Totara Street

Preliminary design stage safety audit

Report prepared for
Tauranga City Council
May 2020

Figure 5: Incorrect alignment of path markings

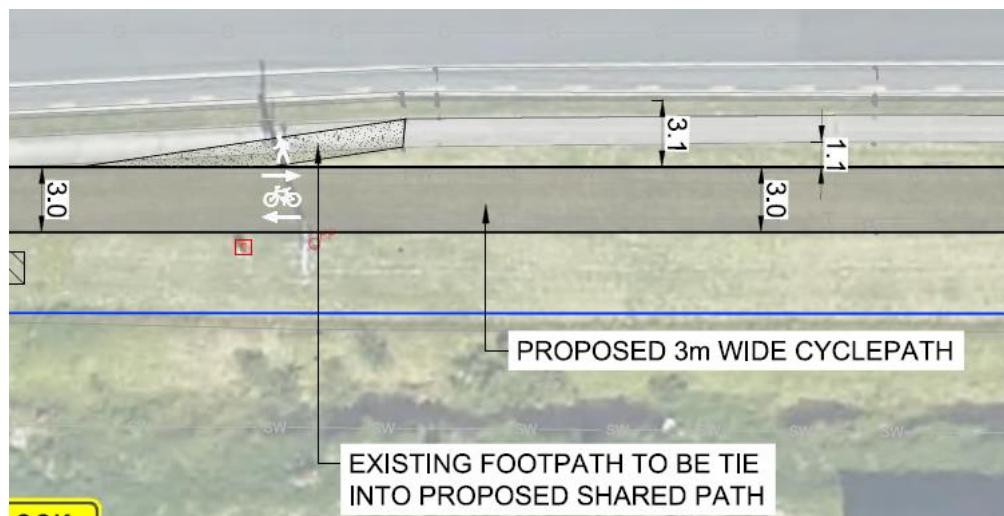
The cycle and pedestrian symbols used in path markings should be aligned for view of the path users. Driveway markings, on the other hand, are aligned for view of drivers on the driveway. Figure 5 shows an example of where path markings have been used with incorrect orientation for path users.

2.1.5.1. Realign path markings.

Designer Response: Agree

Safety Engineer: Agree with Designer response.

Client Decision:	<i>Designer to ensure that all road markings are appropriate as outlined by SAT</i>
Action Taken:	<i>Incorporated into design</i>

Figure 6: gate indicated in red dashed line

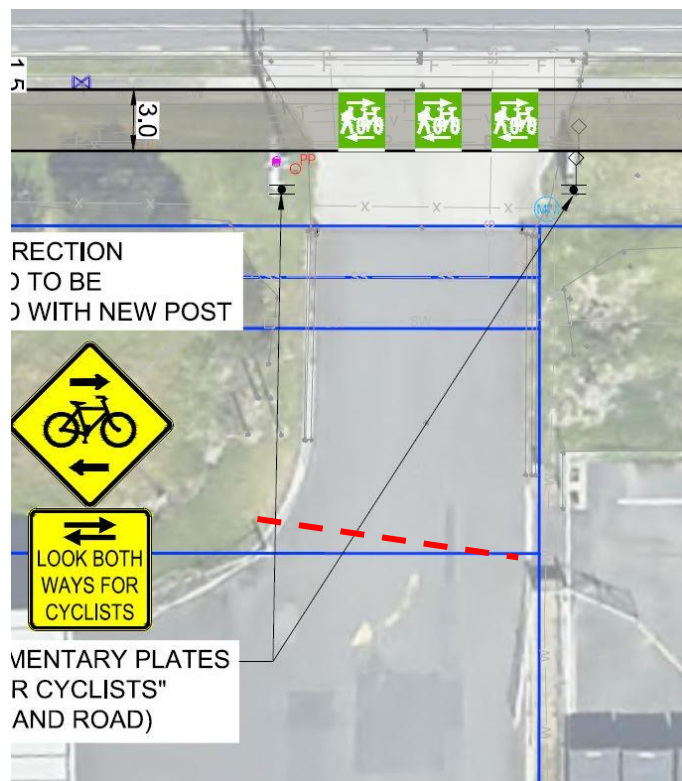
The SAT does not know the operational practice at 207 Totara Street (see Figure 6). There is a gate installed some 20 m beyond the edge of the proposed pathway. An HPMV is 23 m long. If these types of vehicle were to stop at a closed gate, a pathway would be completely blocked.

Recommendations:	
2.2.1.1.	Ensure that there are no operational procedures in place that require entering HPMVs to stop at a closed gate.
2.2.1.2.	Alternatively, shift the gate further into the site.
Designer Response:	<i>Agree with the SAT. TCC will require consultation with the owner/operator to ensure the gates remain open during business hours for use by large heavy vehicles to avoid stopping and encroaching over the shared path.</i>
SAT Response:	no further comment
Safety Engineer:	<i>Agree with Designer response and recommend that TCC make use of any available enforcement options to ensure that the site operator is not creating a hazard (i.e. trailer blocking the thoroughfare) due to their gate procedures.</i>
Client Decision:	<i>Agree, the team to get formal agreement from 207 Totara Street around use of gates. This will be incorporated into comms and engagement plan to ensure action is closed out</i>

Action Taken:	<i>Include in comms and engagement plan and action accordingly</i>

Figure 8: missing pathway markings (highlighted)

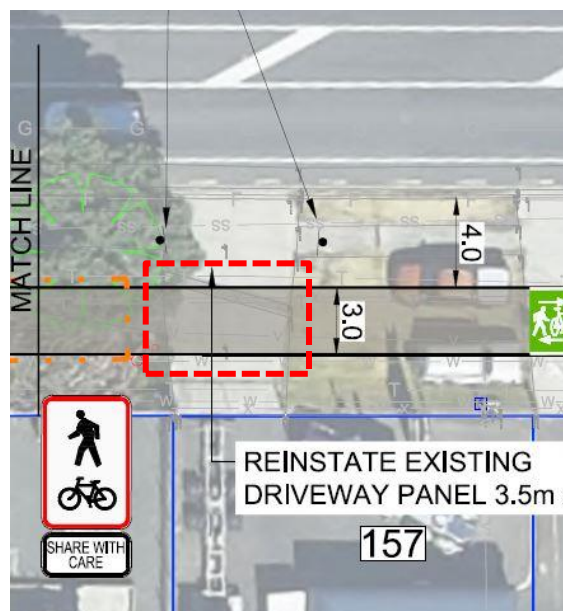
The driveway at 157 Totara Street on sheet C06 is missing the shared path markings (see Figure 8).

Recommendations:	
2.2.3.1.	Add the shared pathway markings.
Designer Response:	<i>Agree markings to be added</i>
SAT Response:	no further comment
Safety Engineer:	<i>Agree with Designer response.</i>
Client Decision:	<i>Agree with Designer response.</i>
Action Taken:	<i>Implemented as part of the design</i>

Figure 9: narrow path over 40 m

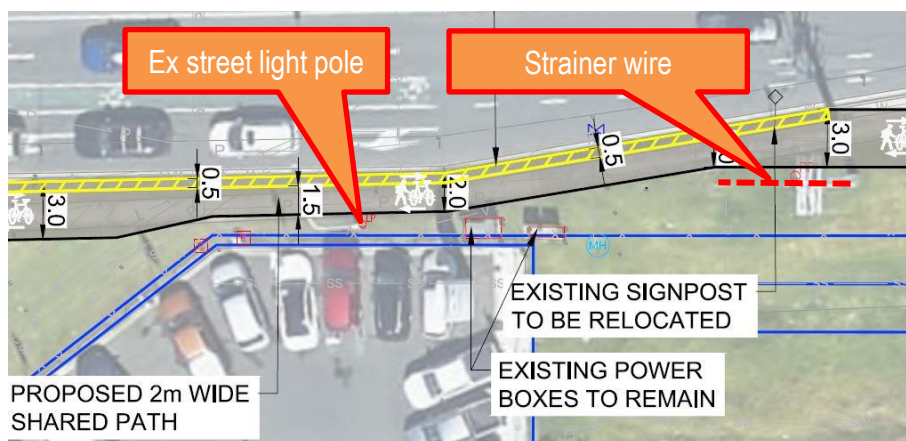
On sheet C01, the shared path narrows to just 2.0 m over a length of some 40 m (see Figure 9). This happens in an area where it is proposed to mark a 0.5 m wide yellow buffer zone, leaving a useable width of just 1.5 m for the shared path. It needs to be noted that it can be commonly observed that vehicles wanting to reach the kerbside lane mount the pathway with their left wheels. Therefore, having such a narrow path in this location is at best undesirable.

It is acknowledged that there is a large electricity box on the boundary that poses an existing constraint, and it may well be acceptable if the path momentarily narrows at that box. There is also an existing street light pole in this narrow section, but this should be easy to relocate.

2.2.4.1. Reconsider the width and alignment of the path shown in Figure 9.

Designer Response: *Agree with the SAT. The designer presented the option to go behind the pole at preliminary stage. This issue has been further debated with the client post scheme drawings and prior to receiving the SAT recommendations. The funding application has been submitted to include the relocation of the power boxes and stay wire holding the terminal pole to allow a full width path to be installed.*

Safety Engineer: *Agree that removing the obstacle(s) would be the preferred solution, subject to funding. However, a pinch-point or short length of narrower path could assist in slowing path users, which would be beneficial in the vicinity of a major intersection.*

Client Decision: *This matter was raised with designer on review of drawings provided to SAT. An alternative of providing a formal signalised crossing across Totara Street is being considered. This will provide a link to the shared path on the Harbour Bridge and avoid potential challenges in crossing the free left turn on Hewletts Road.*

<p>Action Taken:</p>	<p><i>Designer to get prices for undergrounding of poles outside small commercial businesses and relocation of service boxes. Propose that the initial crossing design be incorporated into this design. Modelling results on impacts on network to be shared with NZTA and TTOC to obtain endorsement on this alternative.</i></p>

Figure 11: incomplete design at the Waimarie Street approach

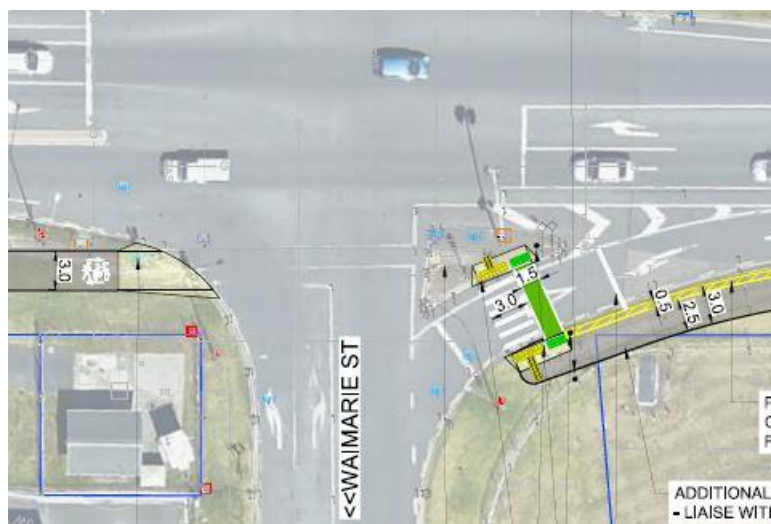
The design for the crossing facilities at Waimarie Street is incomplete (see Figure 11). The dual crossing is wider than the current cut down on the splitter island. The crosswalk is much narrower than the shared path approaching it. The limit line for the Waimarie Street approach is within the extension of the shared pathway; the limit line will have to be relocated. With the design not adequately detailed, it is not possible to provide safety audit comments.

Recommendations:	
2.2.5.1.	Provide a design that can be safety audited.
Designer Response:	<i>Agree with SAT. The designer is aware of these issues which will be addressed during the next phase.</i>
SAT Response:	no further comment
Safety Engineer:	<p><i>Agree that the signals layout will need to be modified to suit the width of the shared path.</i></p> <p><i>Also, on the issue of priority on the non-signalised left-turn from Totara into Waimarie, we note the following. The volume of pedestrians and cyclists on the shared path is expected to be relatively low. The volume of vehicles using the left-turn slip is also expected to be very low. However, the majority of vehicles are expected to be heavy vehicles. Given that both parties are expected to have a very high level of service regardless of who has priority, it may be beneficial to maintain the existing vehicle priority arrangement on the slip.</i></p>

Client Decision:	<i>Agree with SAT. Given we experience more than 100 cycles on weekends within an hour, it is recommended that priority be given people biking and walking, and equally raises awareness by truck drivers on the approach.</i>
Action Taken:	<i>Designer to include actions in developing design.</i>

Figure 12: Missing broken yellow lines shown in red

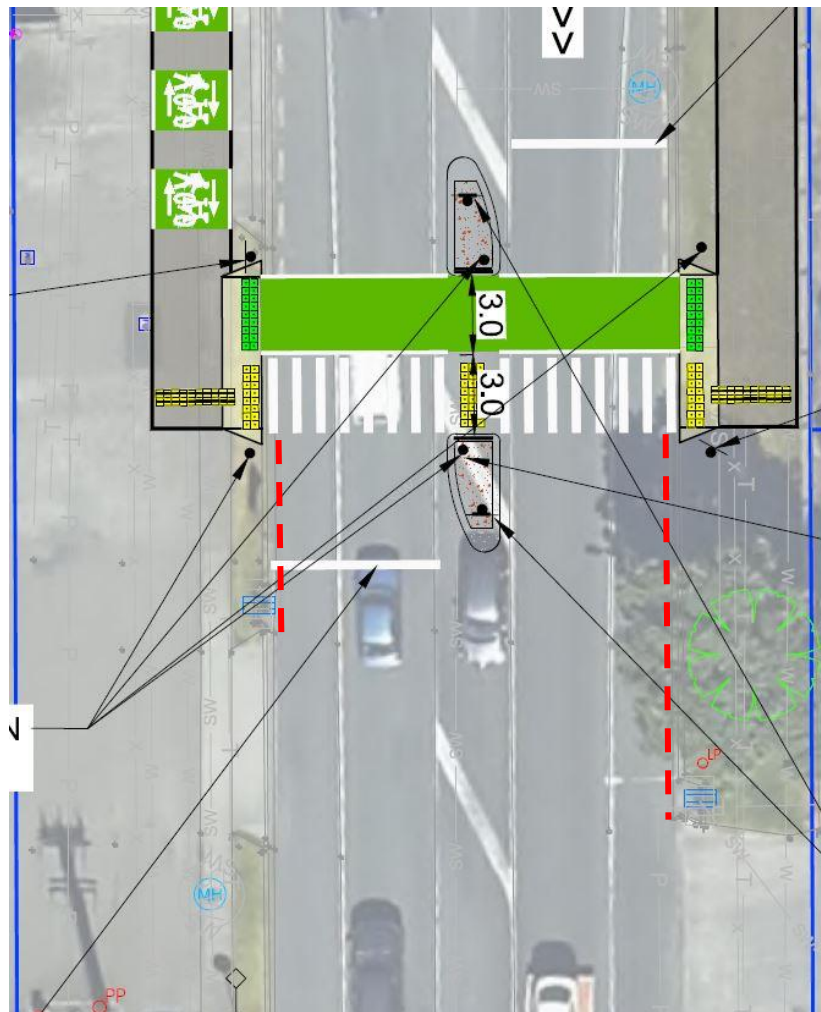
Ranking – Comment
<p>Broken yellow lines have inadvertently been left off sheet 07 as shown in Figure 12. On the approach, broken yellow lines should be included to ensure that there is good intervisibility. On the departure side, broken yellow lines would prevent a squeeze point at the refuge island for people cycling on the carriageway.</p>

2.2.6.1. Add broken yellow lines to the design.

Designer Response: Agree

Client Decision: Agree

Action Taken: Include appropriate byls
